AGENDA
CHARTER TOWNSHIP OF MERIDIAN
PLANNING COMMISSION – REGULAR MEETING
July 8, 2019 7PM

**CHARTER TOWNSHIP OF MERIDIAN
PLANNING COMMISSION
REGULAR MEETING MINUTES**

To: Planning Commission

SHEET NO. C4.0

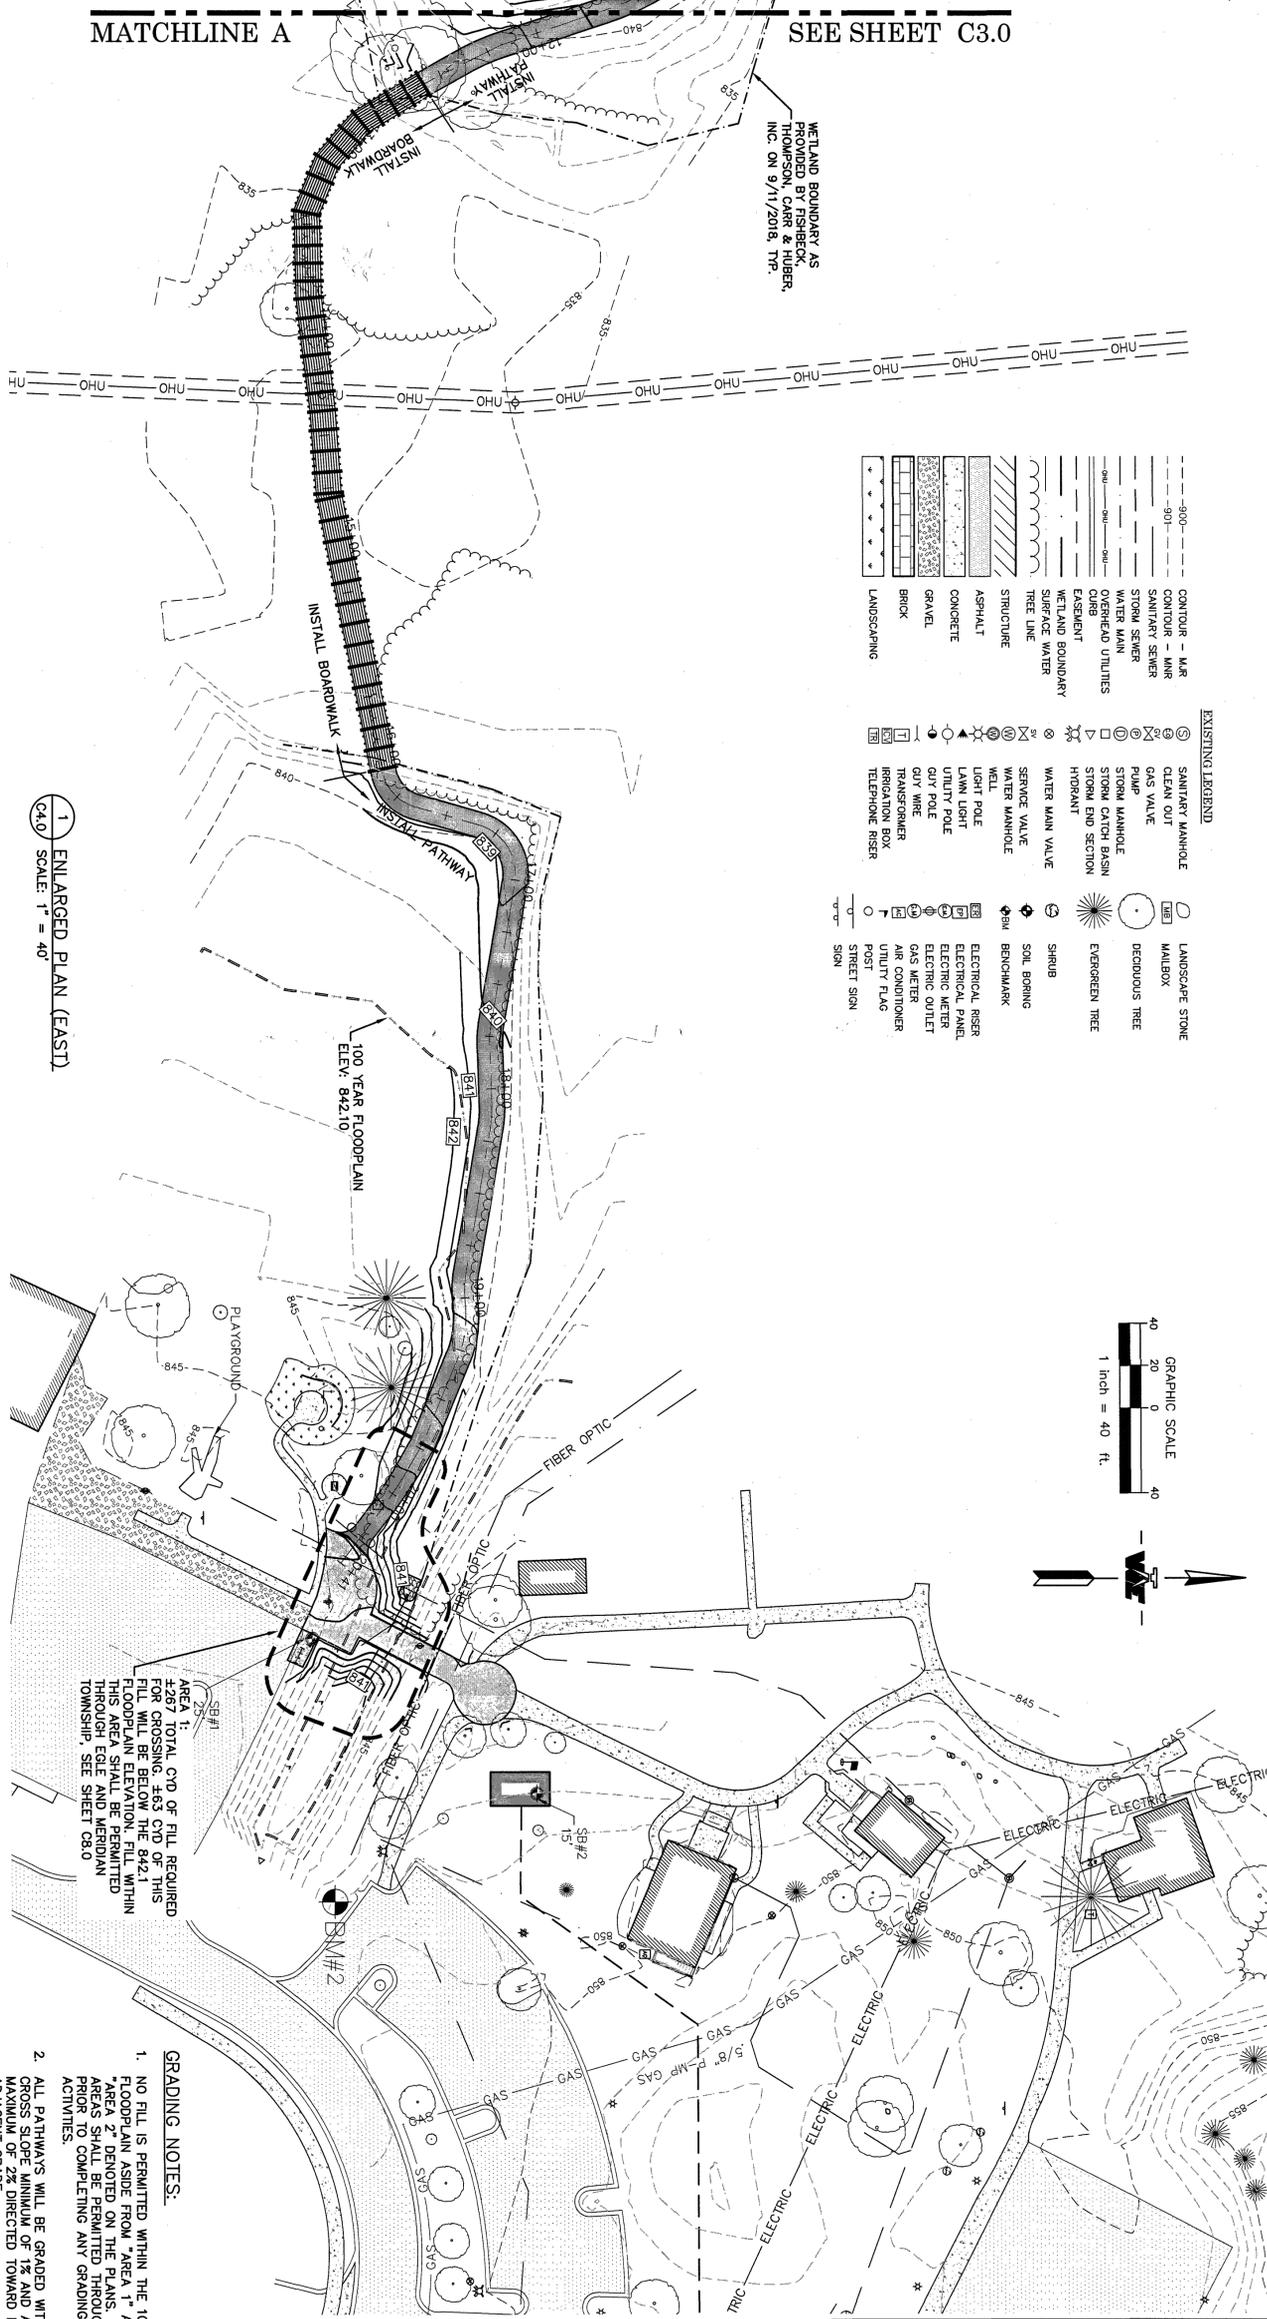
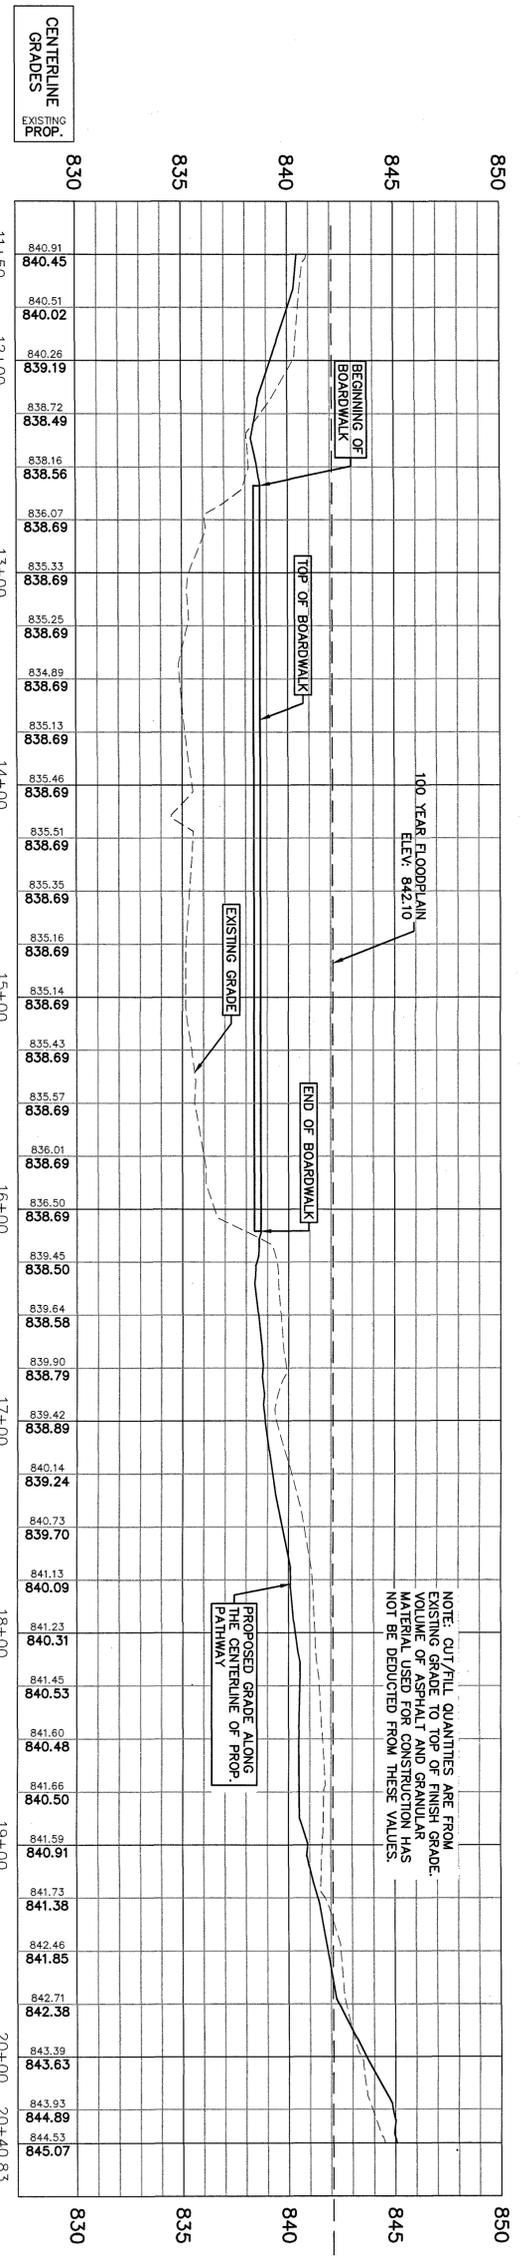
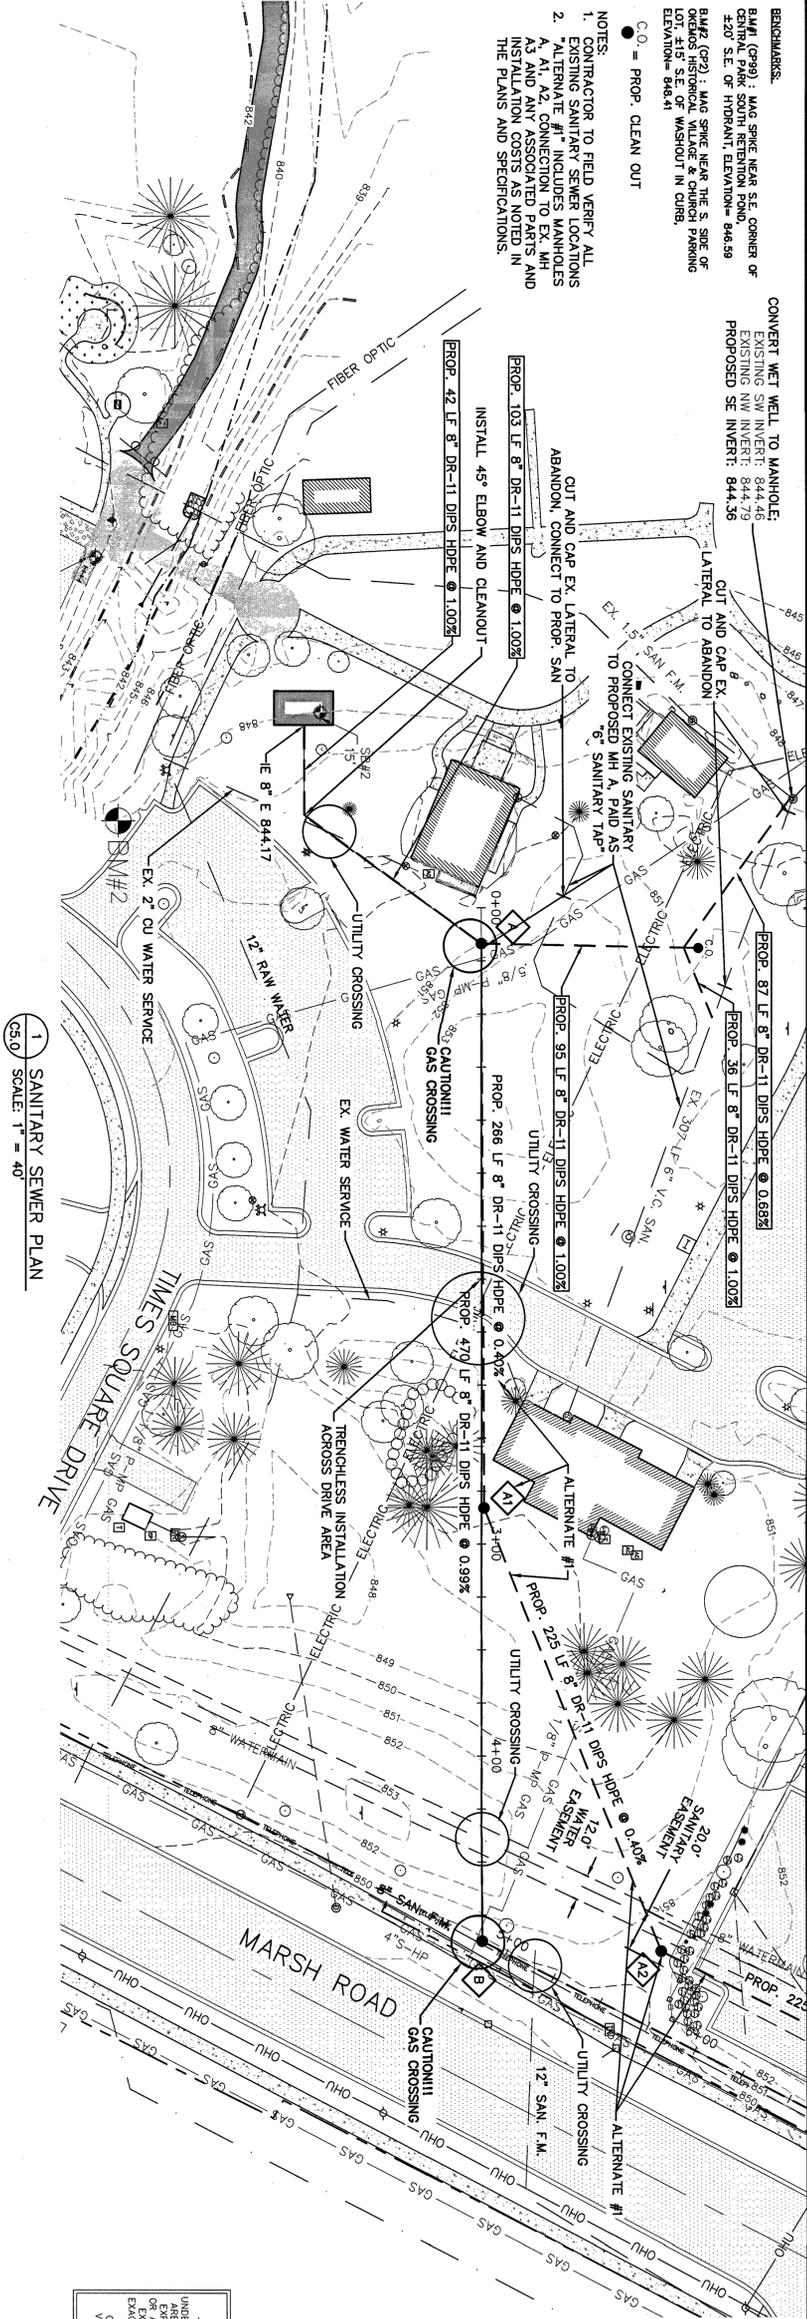
Clarify plan table on sheet C4.0

Table has been removed from plans as it related to cut and fill for the entire project and not just work within floodplain/wetland areas. Please see "Correction request statement" and notes/cross-sections shown on sheets C7.0 & C8.0 for additional cut/fill information.

PROJECT	APPROVED
CHECKED	DATE
DRAWN	SCALE
AS NOTED	SHEET NO. C7.0

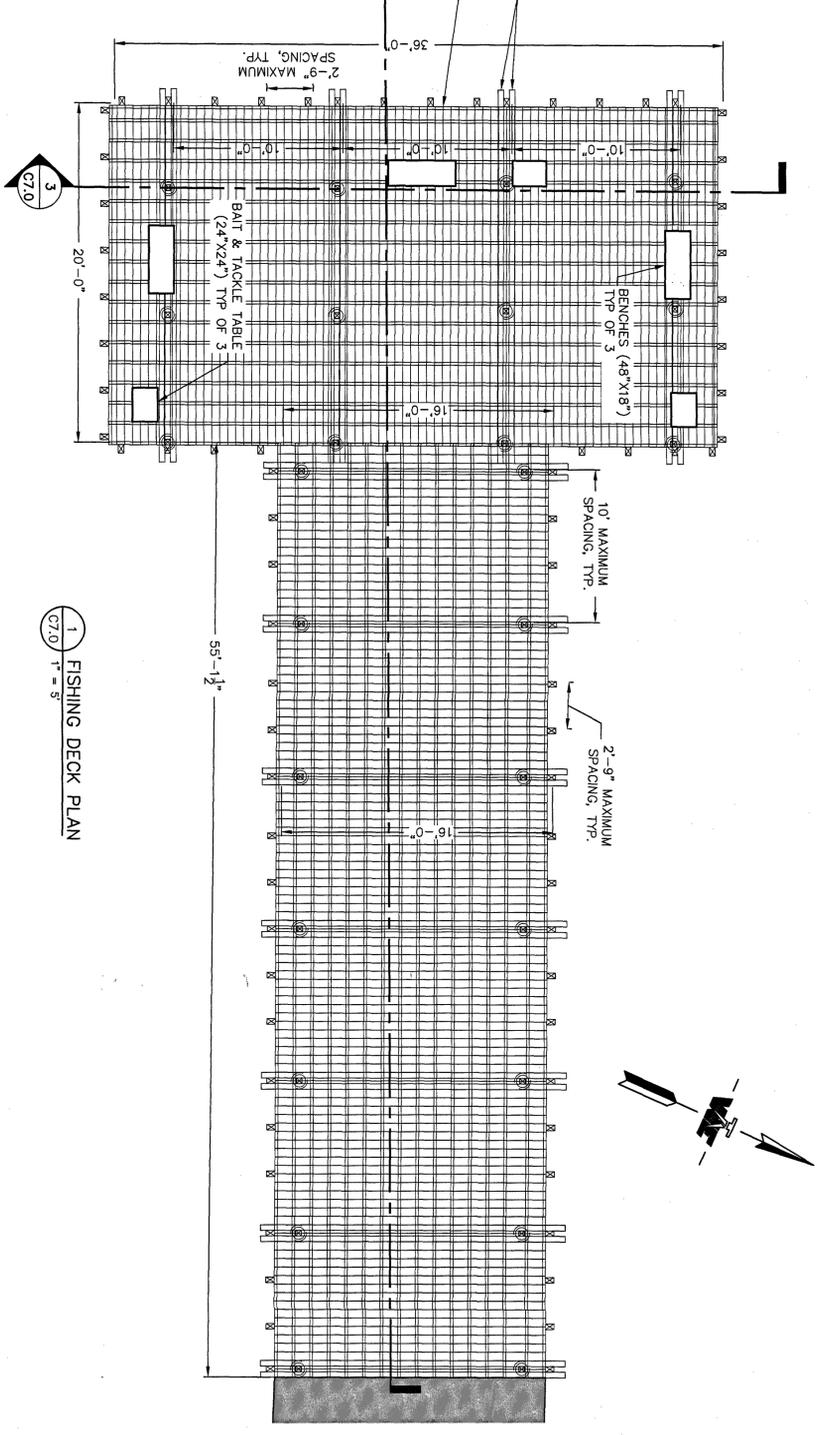
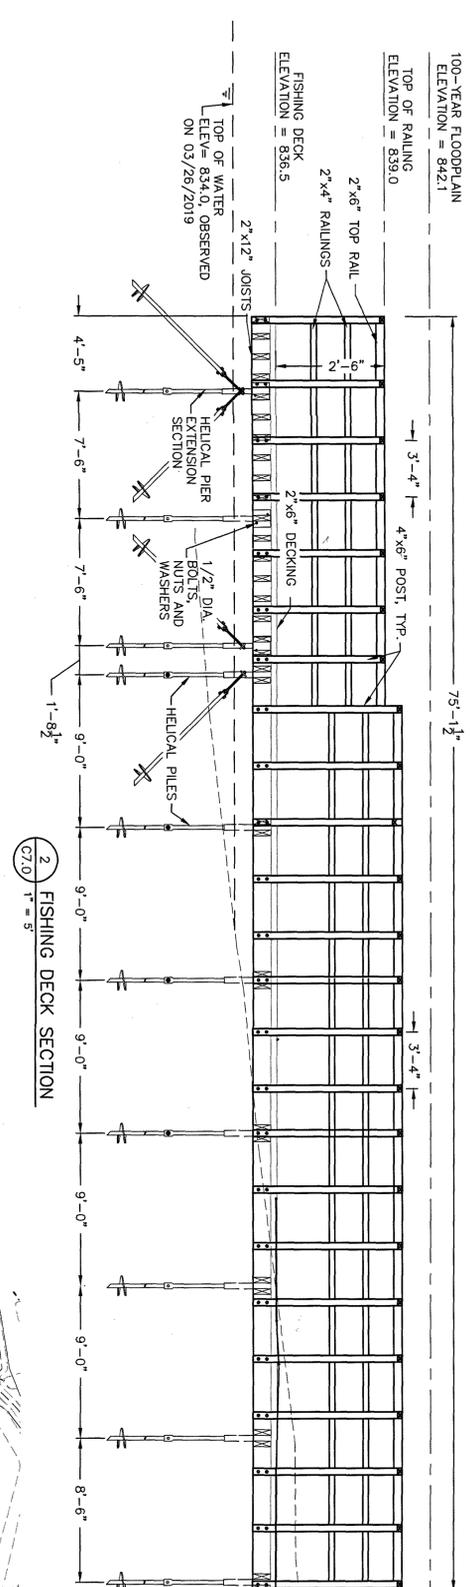
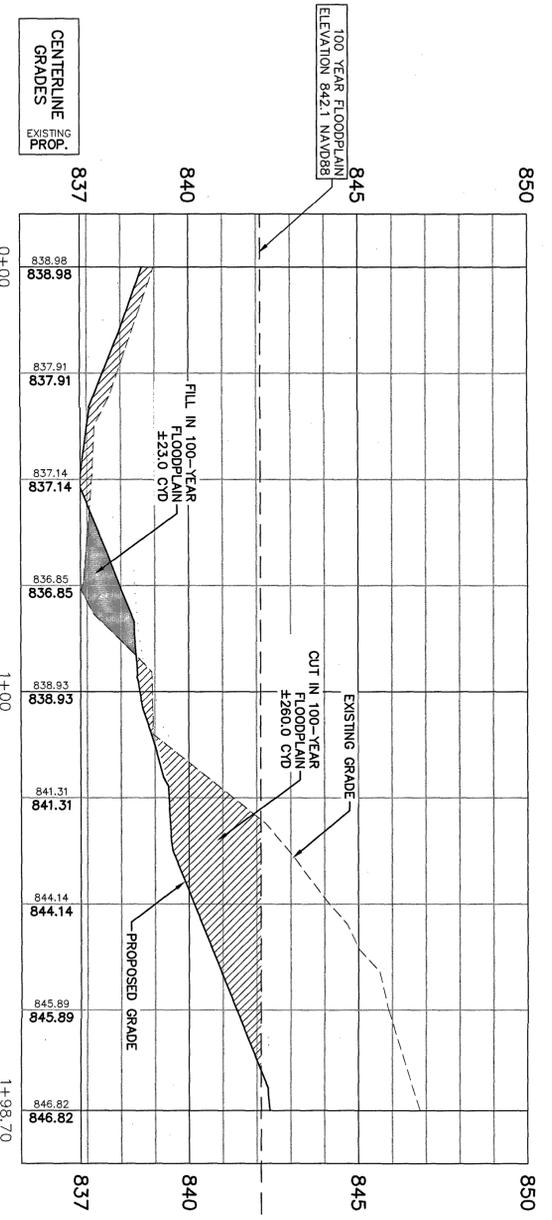
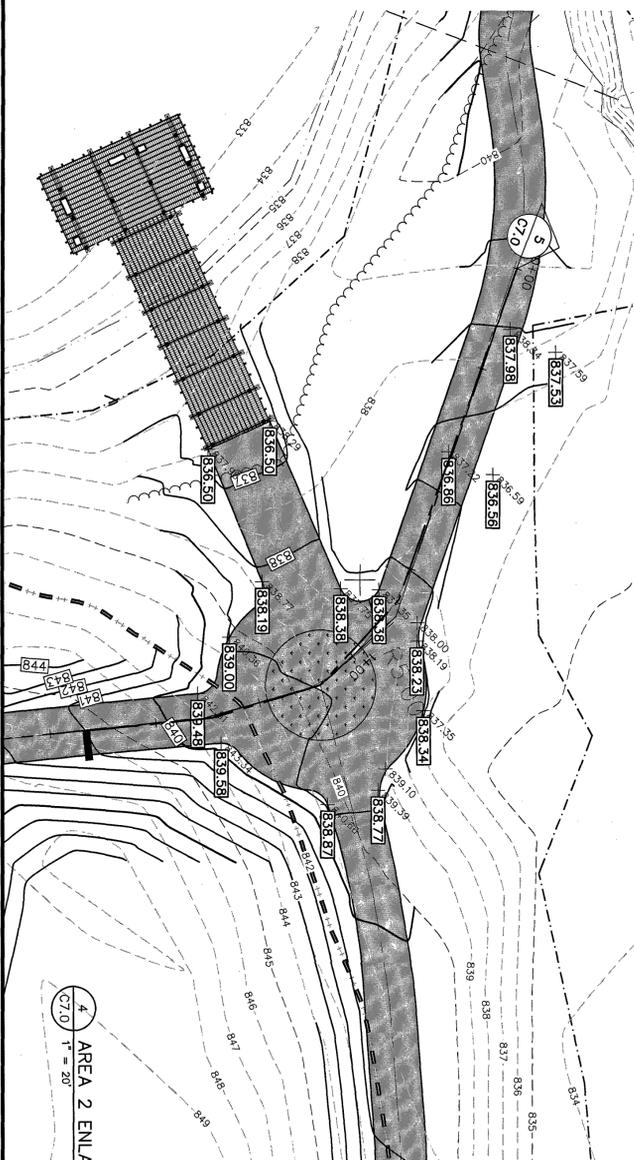
Please clarify the volume of fill or excavation related to the boardwalk and fishing deck. Specifically list the volume of excavation associated with installing pilings or leveling the existing grade to prepare to install the pilings of the boardwalk and fishing pier. Also identify the disposal location of spoils (non-wetland, non-flood plain, and on township owned property). Part 2: Sheet C8.0 shows 180 feet of 15" RCP and a new bioswale over the 15" pipeline. This appears to be work in wetland and a replacement of existing pipe. This work is not listed in the application but shown on plans and does not appear to be associated with or included in the trail head path work. Provide wetland impact details of area and volume for the pipe replacement.

NOTE: CUT AND FILL QUANTITIES SHOWN IN DETAIL 5/C7.0 ARE FOR "AREA 2" ONLY.
